**Collingwood South Mixed Use Precinct
Draft Yarra Planning Scheme Amendment C293yara**

Yarra Activity Centres Standing Advisory Committee Report 2

19 May 2022

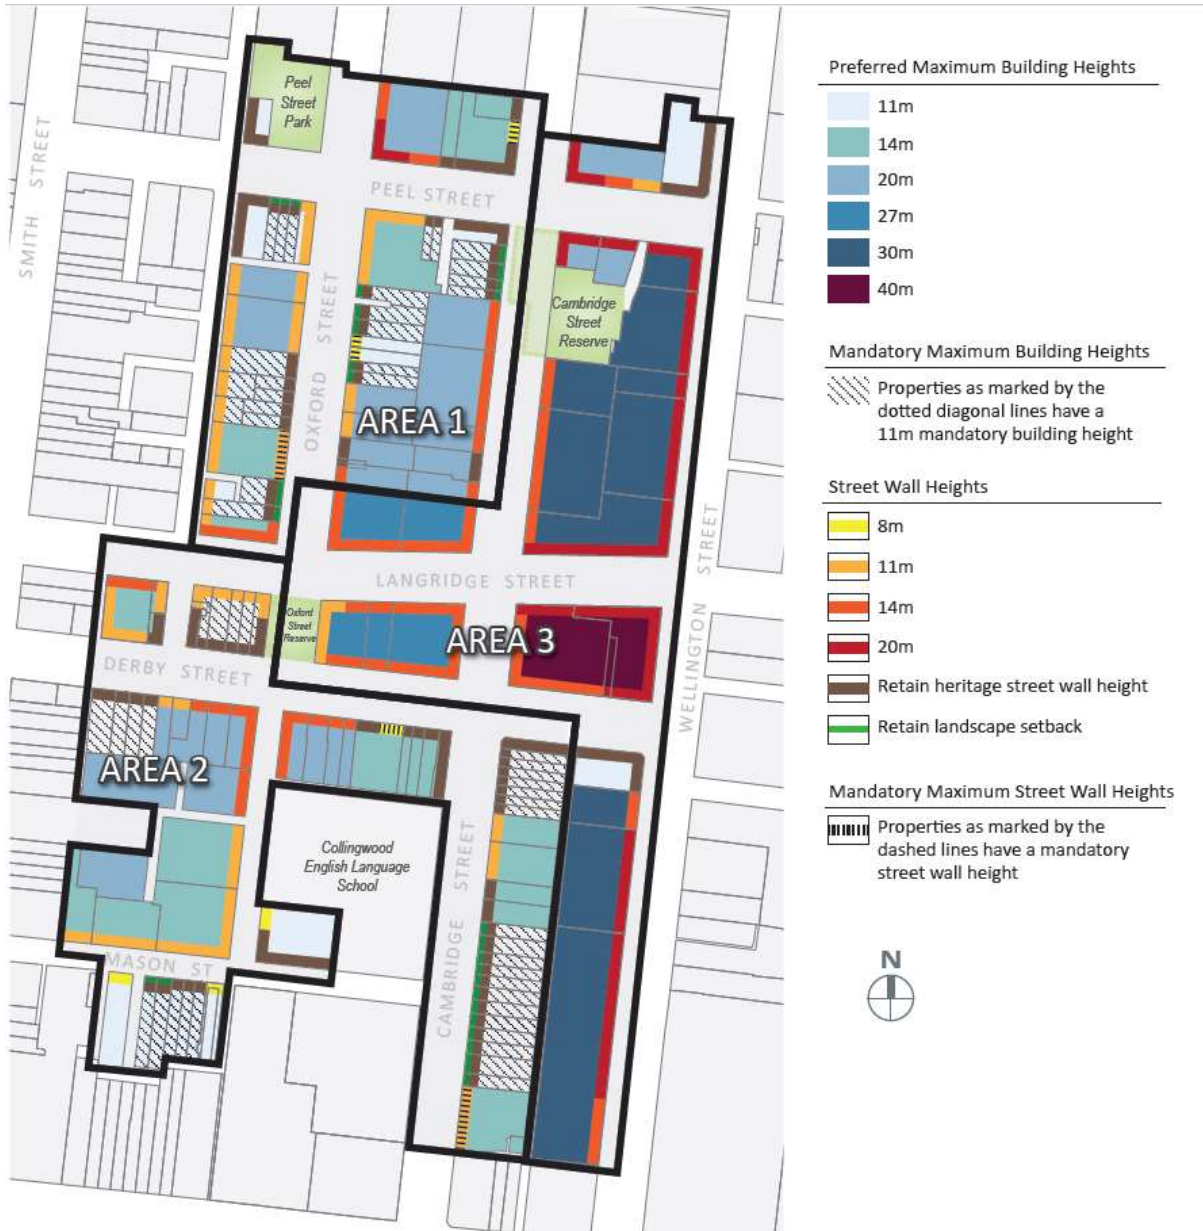
A permit should only be granted to construct a building or construct or carry out works which exceeds the [preferred maximum](#) building height shown in Map 1 where all the following requirements are met to the satisfaction of the responsible authority:

- the built form outcome as a result of the proposed variation satisfies:
 - the Design Objectives in Clause 1.0;
 - the Overshadowing and Solar Access Requirements in Clause 2.6;
- the proposal will achieve each of the following:
 - greater building separation than the minimum requirement in this schedule;
 - ~~excellence for environmental sustainable design measured as a minimum BESS project score of 70%.~~
 - no additional overshadowing impacts to residentially zoned properties, beyond that which would be generated by a proposal that complies with the preferred building height;
 - ~~provision of end-of-trip facilities, including secure bicycle parking, locker and shower facilities and change rooms in excess of the requirements of Clause 52.34.~~
 - ~~where the proposal includes dwellings, it also achieves each of the following:

- ~~housing for diverse households types, including people with disability, older persons, and families, through the inclusion of varying dwelling sizes and configurations;~~
 - ~~accessibility provision objective that exceeds the minimum standards in Clauses 55.07 and/or 58m as relevant; and~~
 - ~~communal and/or private open space provision that exceeds the minimum standards in Clauses 55.07 and/or 58, as relevant.~~~~
